OLD TOWN ROCKWALL HISTORIC DISTRICT

Certificate of Appropriateness - Application

Historic Preservation Advisory Board Memo

AGENDA ITEM: H2003-007; 104 S. Clark-Gates-Porch

**H2003-007 - 104 S. Clark –
Proposed Porch Replacement**

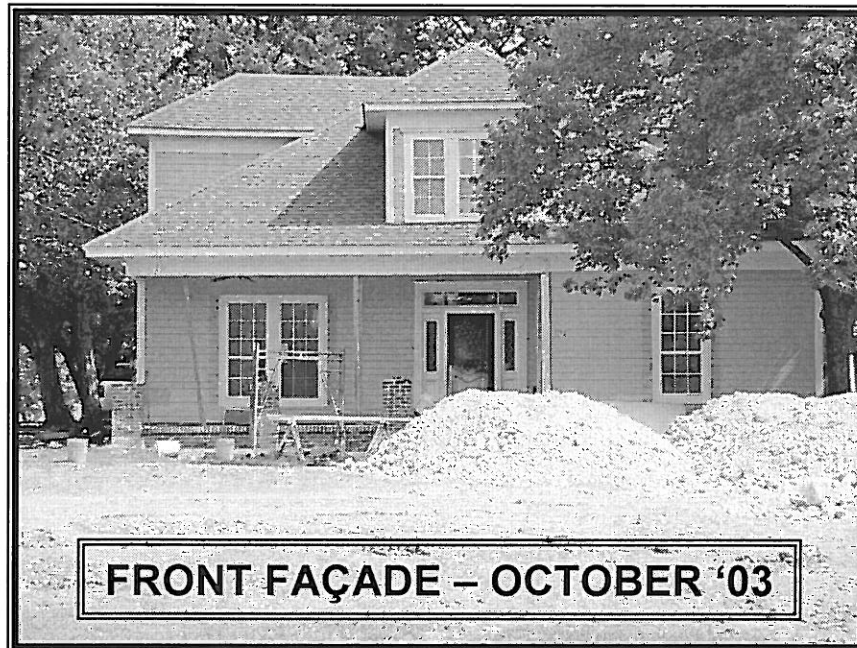
Although the proposed renovation includes a brick element it also retains a portion of the original square posts. A case could be made that the proposed configuration of the replacement porch would serve to differentiate the "new construction" from the original structure as set forth in item nine (9) of The Secretary of the Interior's Standards for Rehabilitation which states:

New additions, exterior alterations, or related new construction shall not destroy historic materials that characterize the property. The new work shall be differentiated from the old and shall be compatible with the massing, size, scale and architectural features to protect the historic integrity of the property and its environment.

On 10/16/2003 the HPAB approved the Certificate of Appropriateness with the Staff condition by unanimous vote 7 to 0.
